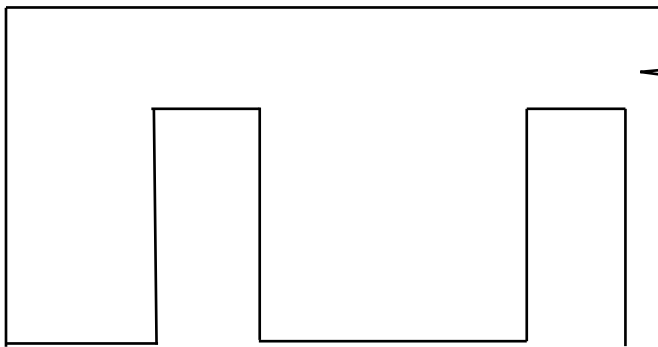
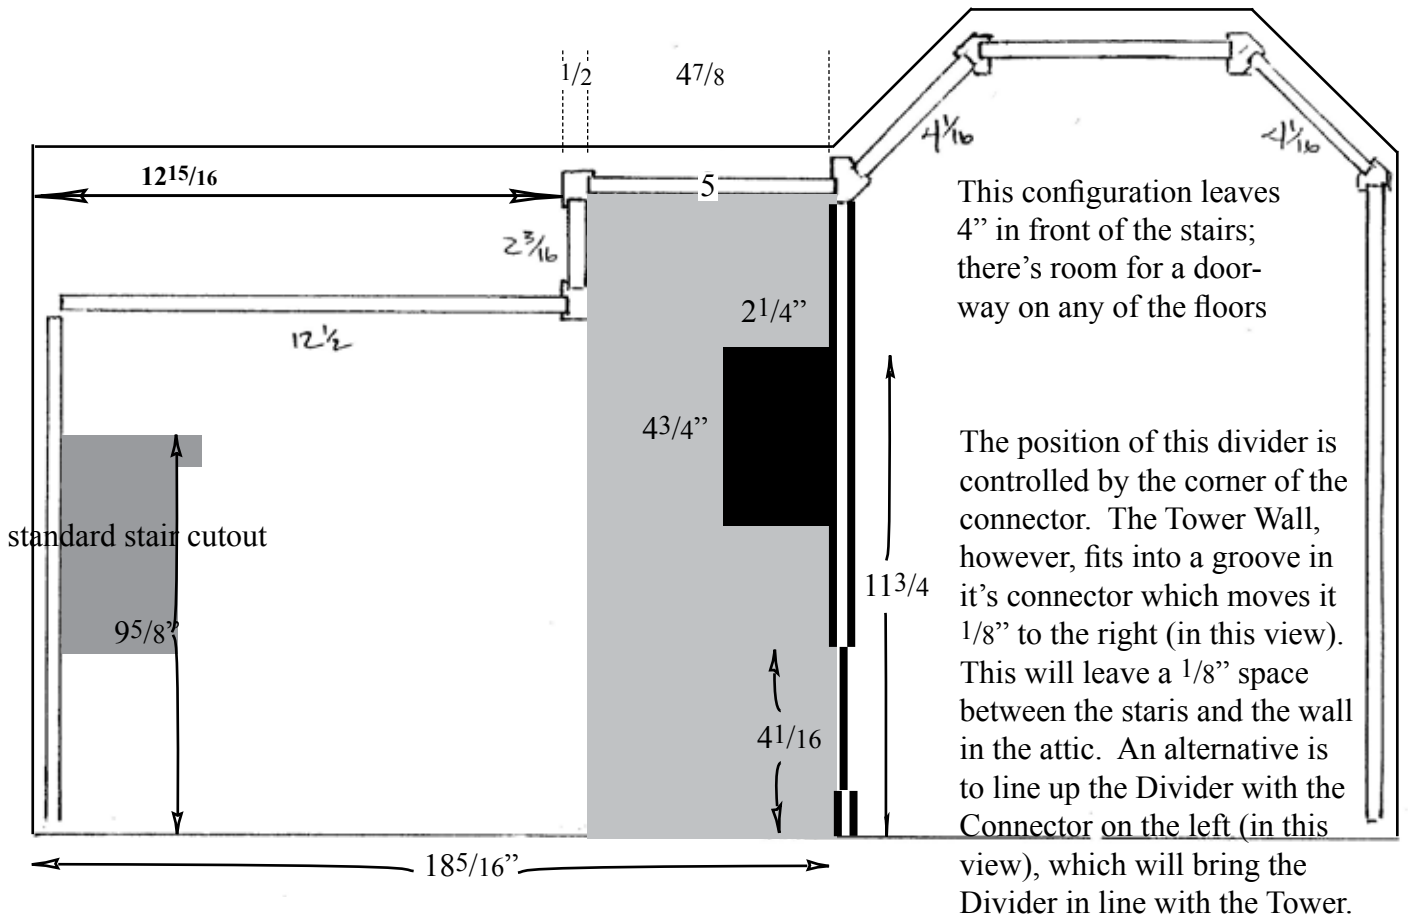
Measuring the stairs in the standard cutout shows a run of about 7"... the hole will have to be moved $2\frac{1}{8}$ " frontward to give $\frac{5}{8}$ " clearance behind a divider door cutout

First floor 2-door divider must be changed from this to this or changed to a 1-door divider
